Department of Energy
National Nuclear Security Administration
Washington, DC 20585

Enclosure: Detailed Response to DNFSB letter of November 19, 2012

In a letter dated November 19, 2012 to the National Nuclear Security Administration (NNSA), the Defense Nuclear Facility Safety Board (DNFSB) identified eight concerns with the Area G safety basis at Los Alamos National Laboratory (LANL). The DNFSB requested a report identifying actions taken or planned by NNSA to resolve these safety issues.

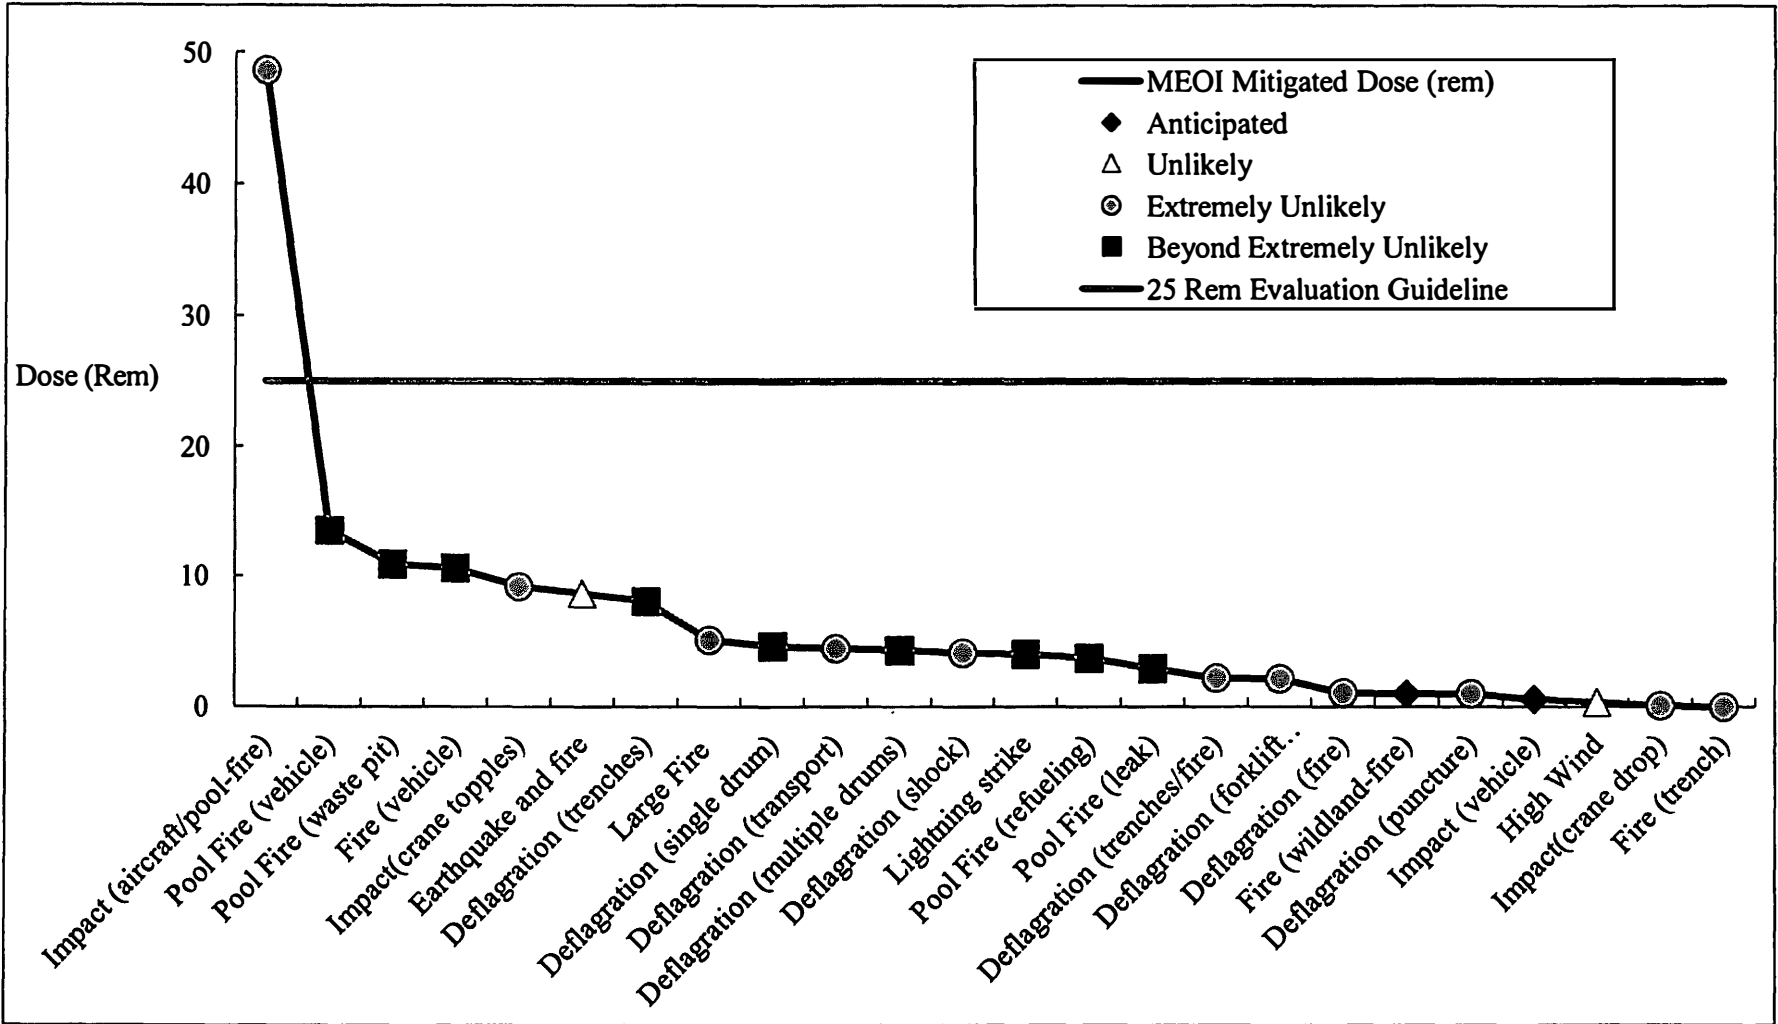
For perspective, Figure 1 presents the calculated mitigated accident frequencies and mitigated doses to the maximally exposed off-site individual (MEOI) for the two dozen detailed accident analyses in the 2012 DSA. The frequency bins (e.g., Anticipated, Unlikely, etc.) correspond to those identified in Department of Energy (DOE) Standard 3009. One accident scenario, the aircraft crash and fire, had calculated consequences exceeding the DOE 25 rem Evaluation Guideline. NNSA accepted this result based on:

3. *Issue – Unanalyzed Hazards:* The Area G BIO does not analyze the puncture of a propane tank or damage to the fuel line on a forklift whereby the escaping gas immediately ignites, resulting in a “blowtorch” effect. This postulated accident could impact both the facility workers and the MAR. This event is credible whenever a forklift is operating within a facility, and it becomes more likely when multiple forklifts are operating simultaneously in the same facility.

NNSA Analysis: The hazard analyses in both the currently implemented and the new but not yet implemented DSA also include deflagration/fire scenarios that are caused by accumulation of flammable airborne concentrations above the lower flammability limit following a gasoline or propane fuel leak or spill. Figure 1 indicates that the 2012 DSA accident analyses included 9 deflagration scenarios and 8 other fire scenarios. The scenarios already covered in the hazard and accident analyses may bound the scenario posed by the DNFSB and its staff.

Action: In the next safety basis annual update, the hazard analysis will explicitly examine the immediate ignition and resulting “blowtorch” from the propane escaping a damaged tank or fuel supply line. If this hazard analysis scenario represents a bounding case, then it will be carried forward to a new accident scenario in accordance with DOE Standard 3009 requirements.
